**PLANNED UNIT DEVELOPMENT
& SUBDIVISION STAFF REPORT****Date: November 17, 2005****DEVELOPMENT NAME**

Pecan Cove Apartments, Ltd.

Truevine Missionary Baptist Church Subdivision

LOCATION1801 Holt Road
(North side of Dr. Martin Luther King Jr. Avenue,
extending Northeast to Holt Road, and extending
Northwest to Yukers Street)**CITY COUNCIL
DISTRICT**

SUBDIVISION PLAT

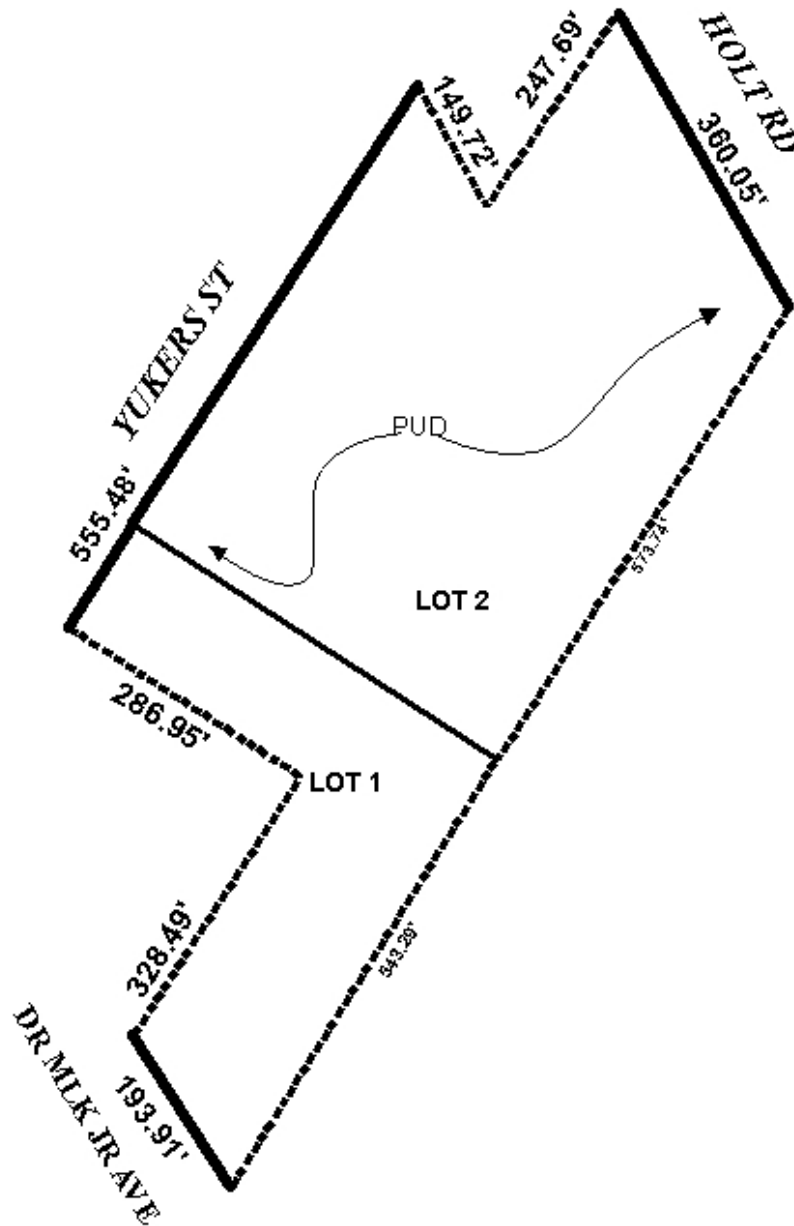
Regarding the proposed subdivision, the site meets most of the minimum requirements of the Subdivision Regulations. However, there is an outparcel that was separated from the parent parcel after the Subdivision Regulations went into effect; as it is also owned by the applicant, this parcel must be included in the subdivision application to bring it into compliance. This will necessitate revision of the legal description of the property, and submission of additional notification fees, and lot fees (if the parcel is included as a separate lot). If proposed Lot 1 is to be used as part of the church property, it should be combined with the outparcel as a single lot.

RECOMMENDATION *Subdivision* Based on the preceding, this application is recommended for holdover until the December 15th meeting, to allow the applicant to submit a revised plat including the Southwestern outparcel, a revised legal description, and any additional notification and lot fees. These materials should be received by Urban Development by November 21st.

SITE PLAN

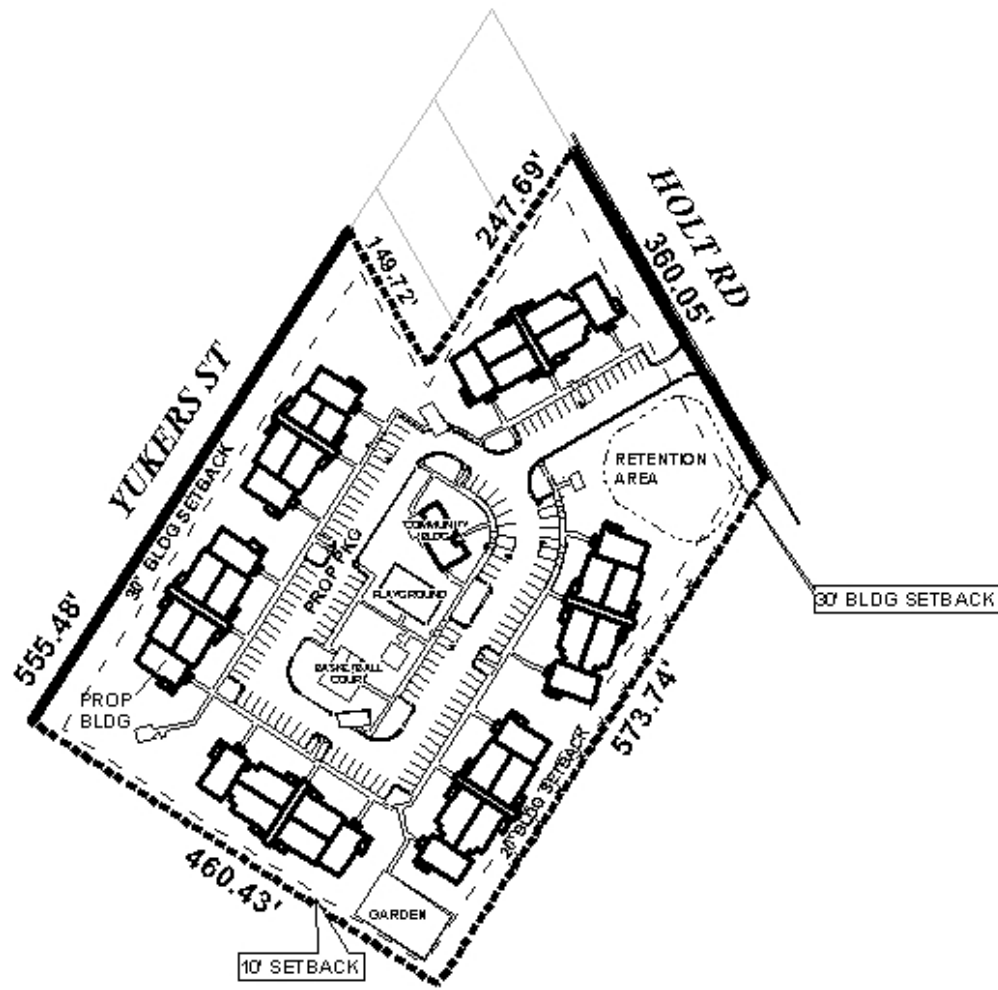
The site plan shows 120 parking spaces, which would exceed the requirements for the 60 units. Circulation and maneuvering meet the standards of the Zoning Ordinance. The site also exceeds the common open space requirements for a 60-unit complex. Building spacing appears to be adequate, with the shortest distance between buildings being 30 feet. If the buildings exceed 30 feet in height, building spacing must comply with Section V.C.2.b. of the Zoning Ordinance (*"A building shall be located no closer to another building than a distance equal to the height of the taller building of the two...[and] for a two-story building such distance shall be not less than 30 feet in the case of two walls having windows...."*).

Regarding the location and general compatibility of the site, a number of houses along Oak Drive Court, to the Southeast, back up to the site; and perhaps more significantly, nearly all the houses along Yukers Street face the site. The site is currently undeveloped, and the residents of these neighboring houses enjoy views of a large wooded lot. To preserve the natural quality of the site, and the views of the surrounding houses, a vegetative buffer, rather than simply a privacy fence, is recommended for the perimeter of the site; and, to the extent possible, preservation of existing older vegetation is preferable to total replacement with new plantings.
